Product Change Notification

1. ECR #: 26-56784-2
Notification #: 836

- UDM6 - UDM6 ASSEMBLY
- UDF6 - UDF6 ASSEMBLY

UDM6-Thick-Wall

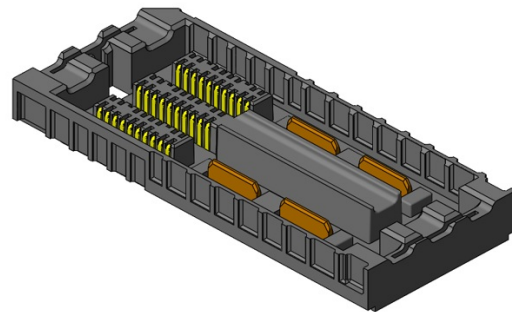
The new revision will utilize thicker side walls, increasing the width of the connector and the keep out region required for PCB layout. PAD and stencil design will not be impacted by this body change. New versions of the connector will not mate with older revisions.

Style	No OF SIGNAL POS PER ROW	No of POWER POS PER ROW	B	Q	R	K
Existing	10	2	24.04	10.85	12.35	2.82
New	10	2	23.95	11.6	14.1	2.86
Existing	10	4	36.04	10.85	12.35	2.82
New	10	4	35.95	11.6	14.1	2.86
Existing	40	2	43.09	10.85	12.35	2.82
New	40	2	43	11.6	14.1	2.86
Existing	40	4	55.09	10.85	12.35	2.82
New	40	4	55	11.6	14.1	2.86

UDF6-Thick-Wall

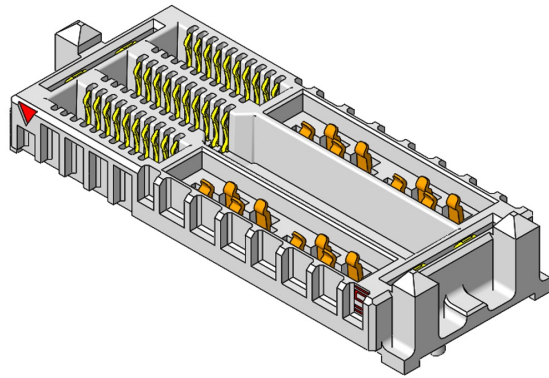
Style	No OF SIGNAL POS PER ROW	No of POWER POS PER ROW	R
Existing	10	2	10.75
New			11.5
Existing	10	4	10.75
New			11.5
Existing	40	2	10.75
New			11.5
Existing	40	4	10.75
New			11.5
